ADDENDUM TO BID DOCUMENT

ADDENDUM NUMBER: #2

BID NUMBER & TITLE: 20-089B Mark Drive Improvements

MARK DR. IMPROVEMENTS
 MATANUSKA-SUSITNA BOROUGH
TYPICAL SECTION

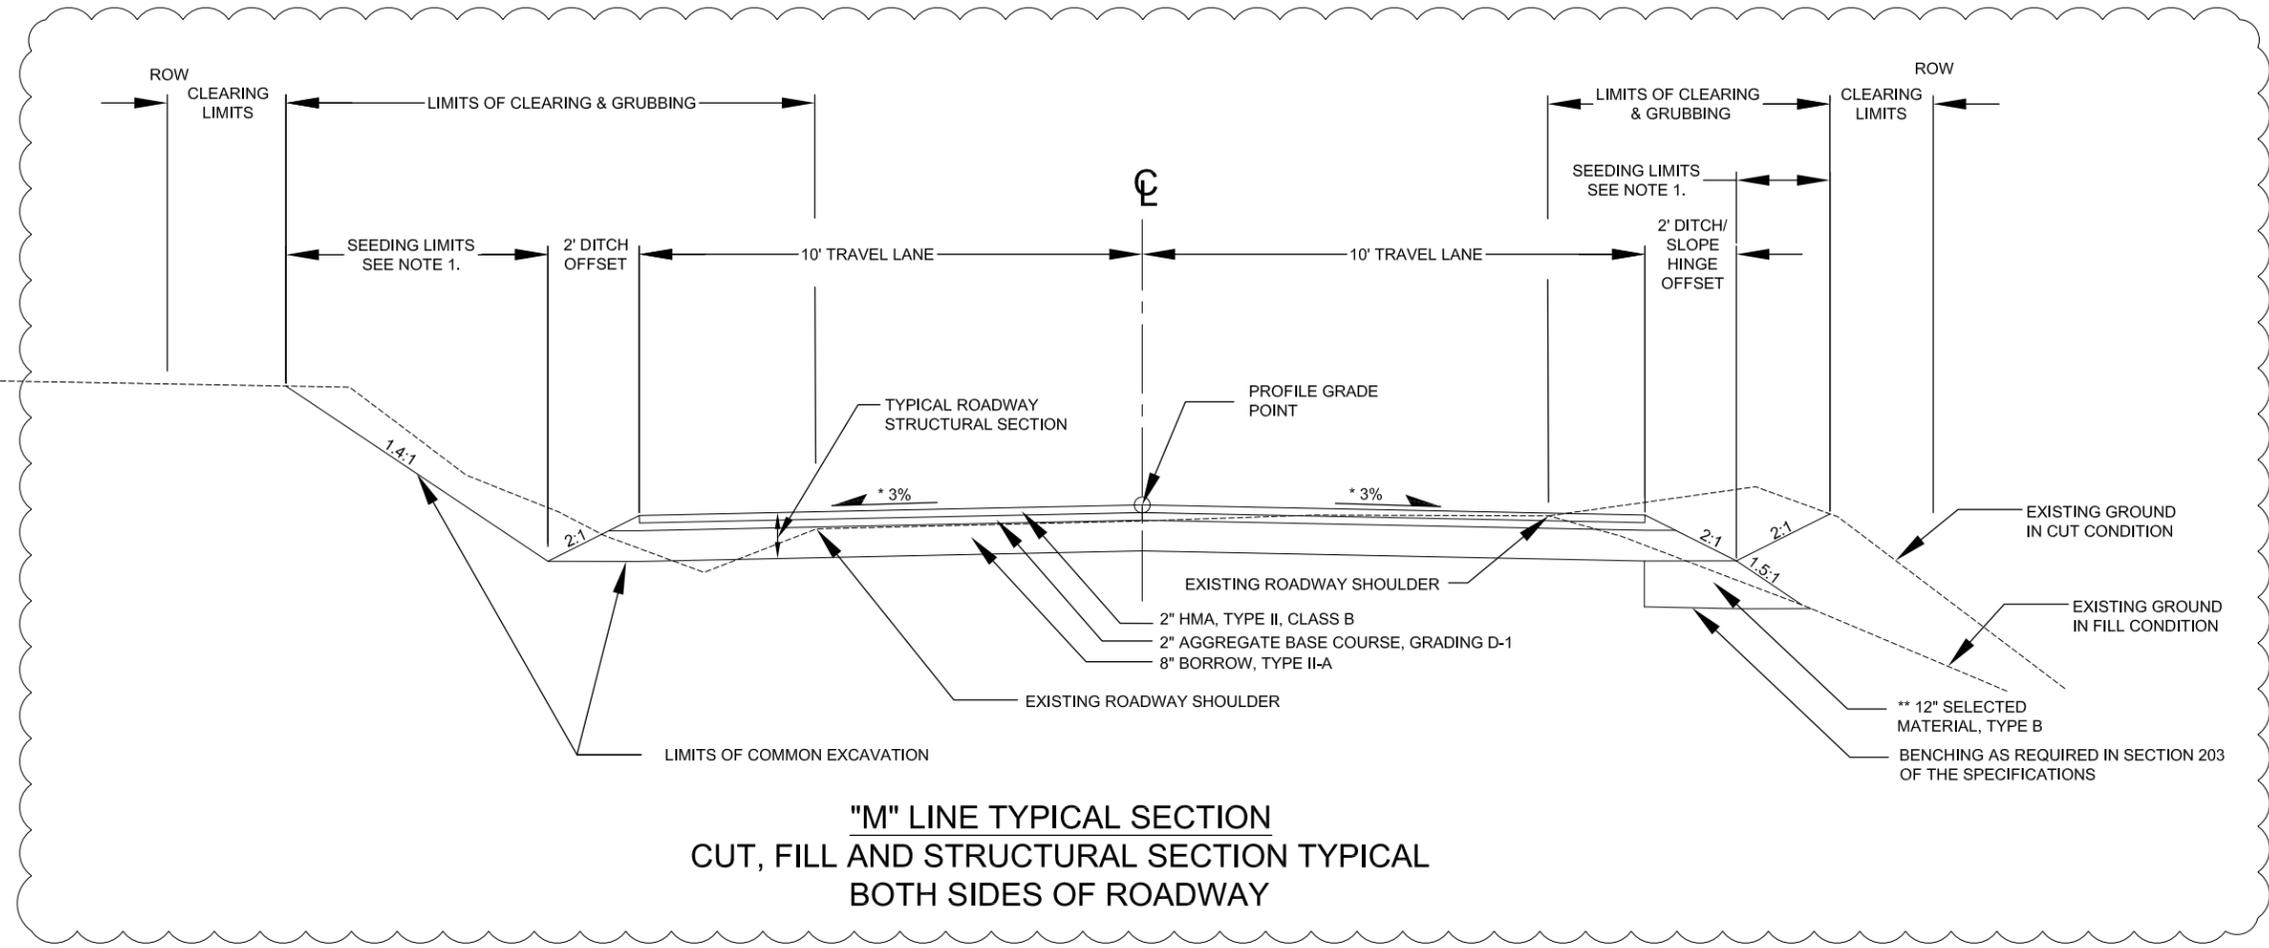
1. **STRIKE** revised Bid Opening date of 2/14/2020 @ 10:00 AM and **REPLACE** with Bid Opening date of 2/18/2020 @ 2:00 PM
2. **STRIKE** sheet B1, dated 10/2/2018, 1 page and **REPLACE** with sheet B1, dated 2/12/2020, 1 page. (see attachment for revised sheet)

1. Q: Where does the 12" select material, type B get placed as shown in the typical section?
A: B1 is revised to clarify that this material is to be used where benching is required per section 203 of the specifications. The cross sections show where the road is to be widened and are accurate.

2. Q: The cross sections for this project do not depict the "Select Material B Prism" as shown in B1.
A: B1 is revised. The cross sections show where the road is to be widened, and show the type B prism, and are accurate. Benching is required per section 203 of the specifications when placing embankment to widen the road and is paid for under unclassified excavation.

SMK	2/12/20	UPDATED TYPICAL SECTION
BY	DATE	REVISION
